U.S. Department  
of Transportation  
Federal Highway  
Administration

In Reply Refer To: HSSD/B-151

This letter is in response to your request for Federal Highway Administration (FHWA) acceptance of a roadside safety device for use on the National Highway System (NHS).

Name of device: Permatile Precast Concrete Barrier 10 foot length  
Type of device: Portable concrete barrier  
Test Level: NCHRP Report 350 TL-3  
Prior Testing conducted by: Texas Transportation Institute (TTI)  
Date of request: March 14, 2008

<b>TITLE:</b> PRECAST TRAFFIC BARRIER SERVICE CONCRETE - 10' V.D.O.T. STD. MB-7D PC (METRIC F-STYLE)	DATE: 9-11-98	DRAWN BY: ROW	DWG NO: VDOTBF.DWG
	PRODUCT: TRAFFIC BARRIER	CHECKED BY: CJR	SCALE: AS NOTED
	CONTRACTOR:	CUSTOMER NO.	SHEET 1 OF 1
	PERMATILE ORDER NO.

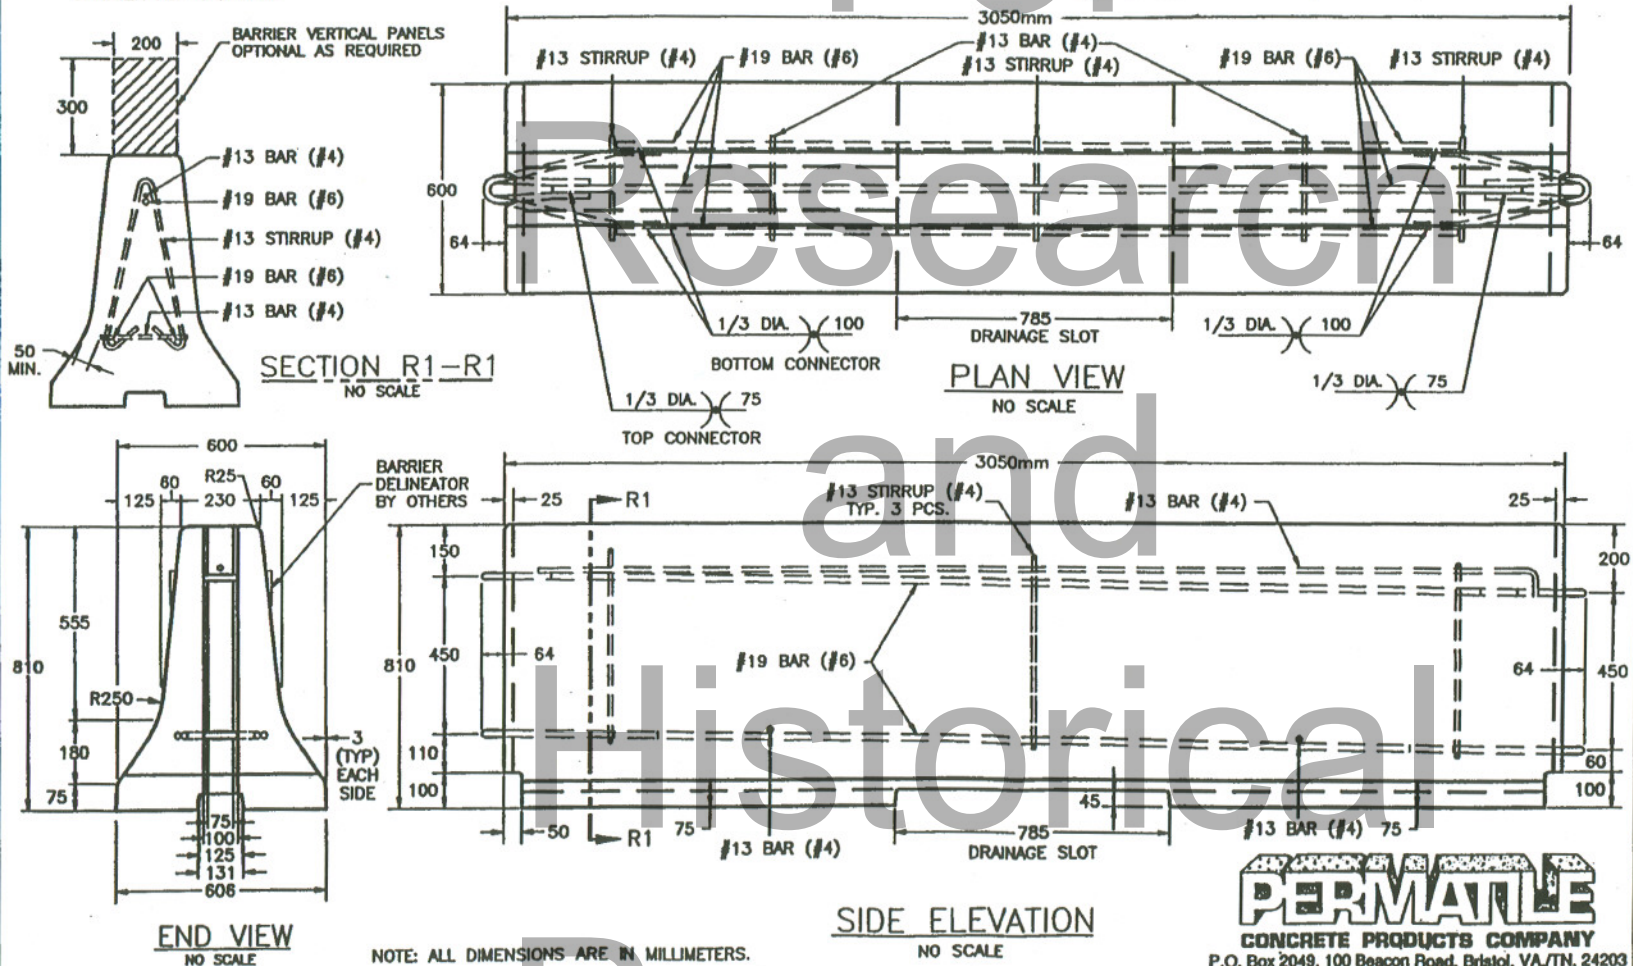
You requested formal acceptance of the Virginia Department of Transportation (VDOT) 10 foot F-shape Concrete Barrier with the pin and loop positive connection. A 20 foot version of this design (Scan01.tif, enclosed for reference) was tested and accepted for use as a TL-3 NCHRP 350 temporary barrier in FHWA Acceptance Letter B-54 dated May 18, 1999. Permatile Concrete Products Company manufactured and supplied this barrier that was tested by TTI under NCHRP report 350 Test 3-11, Contract No. T99011 and Project No. 402041. The drawings "Scan02.tif" and "Scan03.tif" include the details of the 10' version and are enclosed for reference.

The 20-foot long version of the VDOT barrier was successfully crash tested as noted above. Through the observation of crash testing of numerous portable concrete barrier segments of varying lengths over the years FHWA has learned that the length of the barrier plays little, if any, role in the successful performance. As long as the steel reinforcing and the integrity of the end connections are maintained, the shorter barrier length will be acceptable for use.

The 10-foot long VDOT barrier described above and detailed in the enclosed drawings is acceptable for use on the NHS under the range of conditions that the 20-foot barrier was tested, when proposed by a State.
